# Access Compliance Report

## Public Rights-of-Way

Intersection ID: 47660	Main Street: FENWAY_DR	Cross Street: EBBETS_RD	Location: NE
ADA ID: 7C7E38883B37	Ramp Type: PerpDiag	Initial Pass/Fail: Fail	Overall Compliance: No
		Severity Score: 8.75

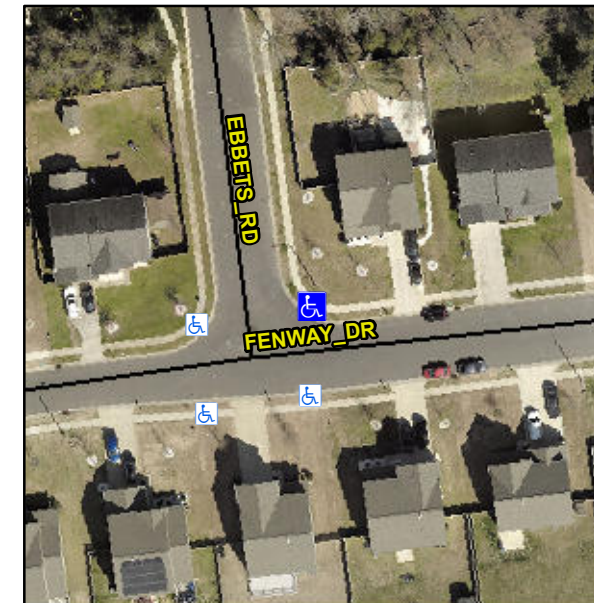
**R304.5.1**

**Remove & Replace Curb Ramp With Two New Directional Ramps or Equivalent.**
